ALTAMONT ZONING BOARD OF APPEALS
Regular Meeting Agenda
March 26, 2024
Altamont Community Room – 7:00 p.m.

Re: CM 11 Lot Subdivision Project-comment letter

We have reviewed the plans submitted on March 18, 2024 for the subject project per our scope of services. We requested a response letter from Mr. Walrath's office on March 18, 2024 which was not in the submission but later emailed from the village staff on 3-22-24. We offer the following comments.

GRADING & DRAINAGE PLAN
MAJOR SUBDIVISION
CM FOX LIVING SOLUTIONS LLC

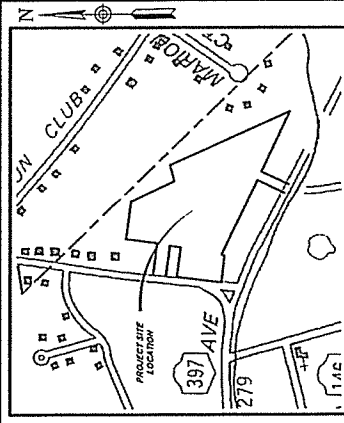
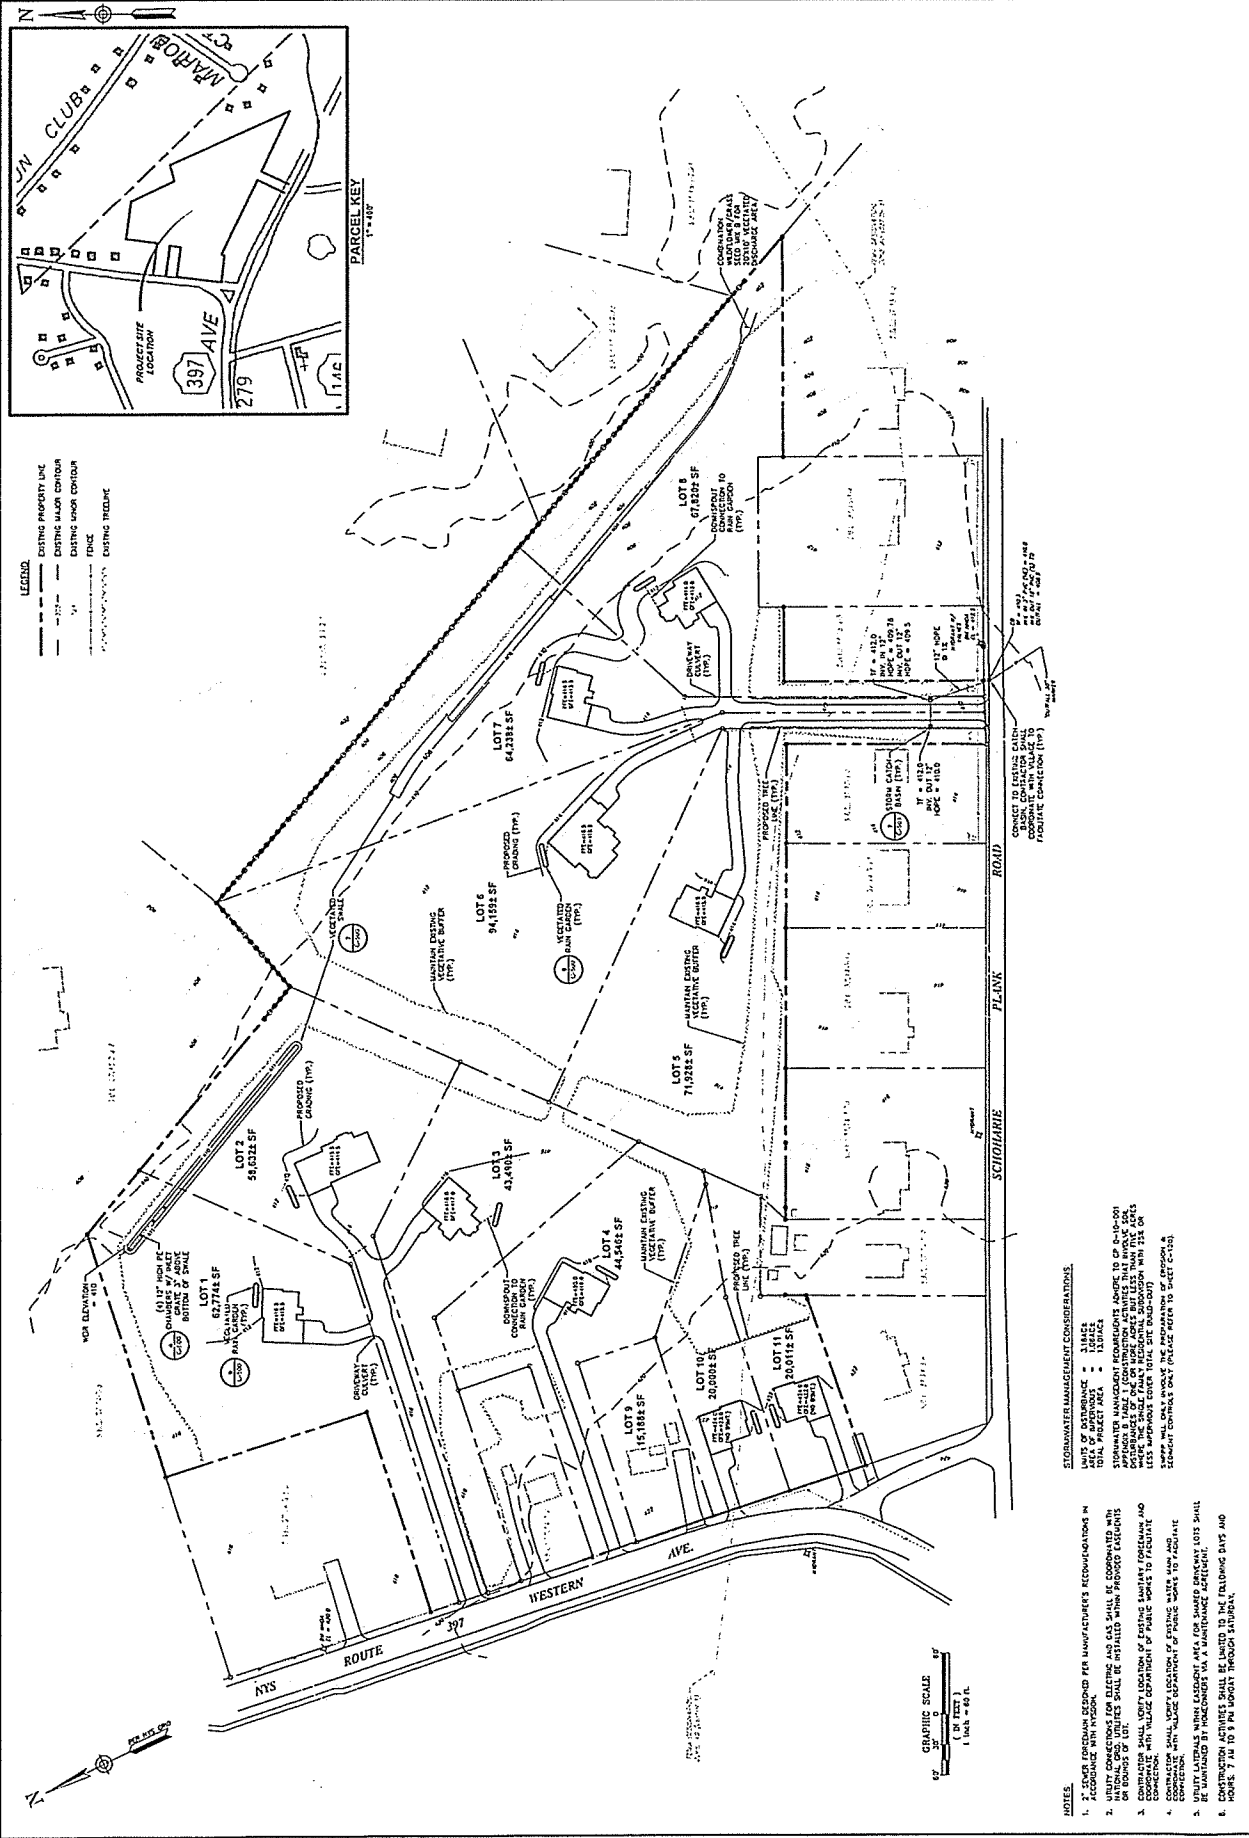
4. The plans do show driveway culverts but the grading plan should include the additional swales and notes on the attached mark-up of the grading plan that informs proper execution of drainage paths and avoidance of stormwater impacts from the project.

5. We recommend moving the proposed rain garden for Lot# 5 to the north side of the house and farther away from the adjacent properties. The attached grading plan swale additions are for the design team's consideration but needed in our opinion to convey drainage to a new swale and culvert inlet along the L5-8 driveway and avoid running off to adjacent property.

1. See attachment and comments above. Runoff conveyance requires additional swales and piping a WSP driveway.
2. Requested shrubbery between driveways for L 5-8 to buffer residences on WSP Rd. adjacent to the driveway were not provided and still recommended. See previous comment letter.

C-150
 SHEET 8 OF 12

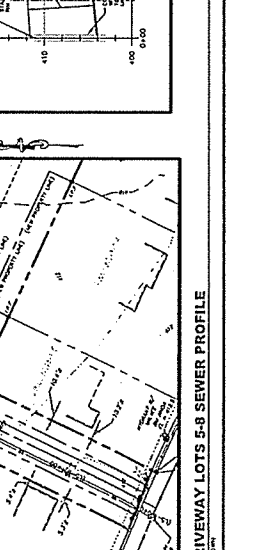
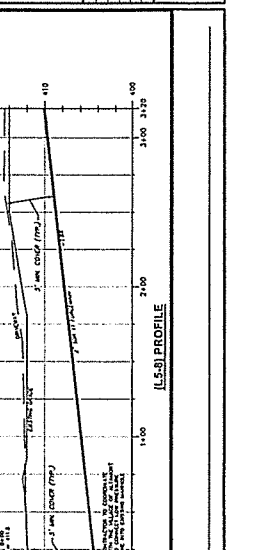
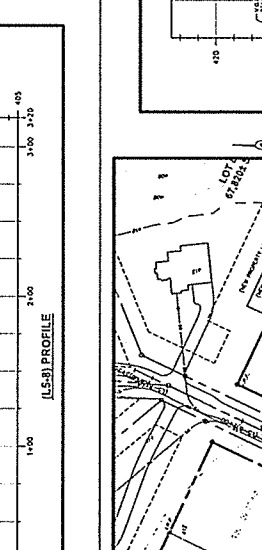
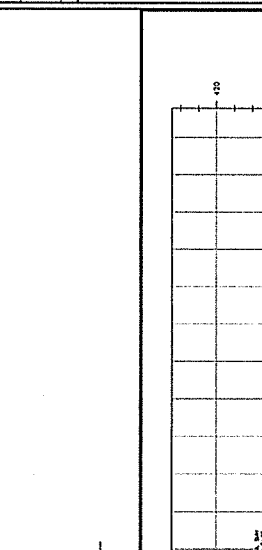
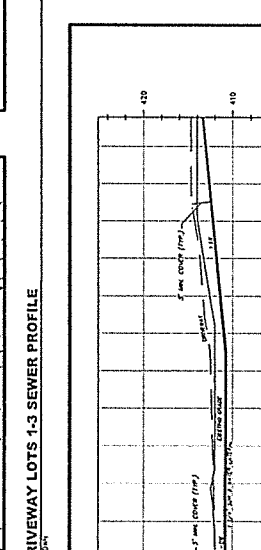
7. Label profile to add proposed grades at every 50' stations for profile L5-8 to ensure constructed pavement meets design attempt. Grades should be greater than 0.80%. Without this and contours on the grading plan a contractor may not meet intent. See attached additions.

2. Provide a profile of each driveway that considers drainage, culverts and conveyance of runoff. Show water and sewer laterals with appropriate cover as already detailed.

Please refer to sheet C-150 Plan & Profile for utility information within common access driveway.
